Quality Control Report

Consultant **Wahib Medanat** Consultant Engineers
Site Name **Khadija Bint Khwailed Basic Mixed - Balqa**
Package **Package 1**
Contractor **Derar Saraireh & Sons for Engineering & Contracting**
Tender No. **1/2020/USAID/SKEP/3/1**

Rep No. **QC-13 09**
Date **14 / 09 / 2021**

Creating a stiffner column in the block wall. (Previous Remark)

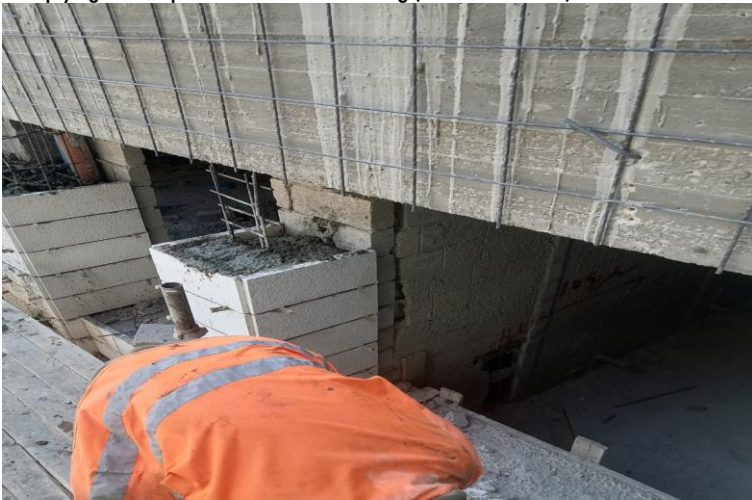
Description of Non Conformance	Corrective Action	Required by / When
<p>1. Roughness observed at the soffit of the lately casted third floor slab.</p> <p>2. Wooden pieces observed remaining at the newly casted structural elements.</p> <p>3. It was observed that the Contractor rectified three previous remarks as follows:</p> <ul style="list-style-type: none"> *Block wall which was not matching with the concrete wall. *Stiffener column within a long block wall. *Process of stone building and creating stiffner columns. 	<p>1. The observed parts should be rapaired using special materials with the required process.</p> <p>2. To be removed before plastering.</p>	<p>The Contractor/Immediately</p>
<p>Report Prepared by</p>	<p>Hassan Shaqbua, Supervision Quality Control Manager</p>
